Re: CDP 2017-0038, Kirkman & Kawase project

Date: May 12, 2021

1) Navarro Knoll with encircled Kirkman house site seen from the Navarro Point Preserve

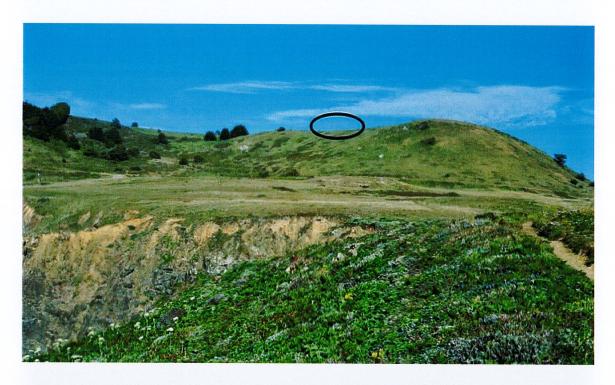
Remembering that a picture is worth a thousand words, I include four photos below of the Kirkman site to more strongly show why I oppose this permit. As these photos illustrate, this proposed home with additional structures on that undeveloped, highly-visible ridge line would degrade this otherwise beautiful natural gateway onto the Mendocino Coast. It would especially create an eyesore to all southbound traffic on Hwy 1 and to people walking in the Navarro Point Preserve and on the Coastal Trail in this area. (See especially photos 3 & 4 below.)

and Coastal Trail in the foreground.

2) Kirkman story polls above Hwy 1 and the Navarro Point Preserve.

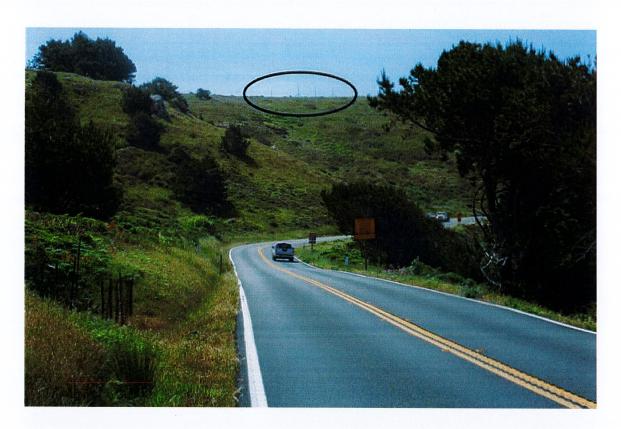
Not only is a 3383-square-foot, two-story house plus 488-square-foot garage planned for the Kirkman site, but also a covered deck and walkways, two water tanks, two solar arrays and three windmills, nearly all of which would be highly visible from Hwy 1 and the Navarro Point Preserve.
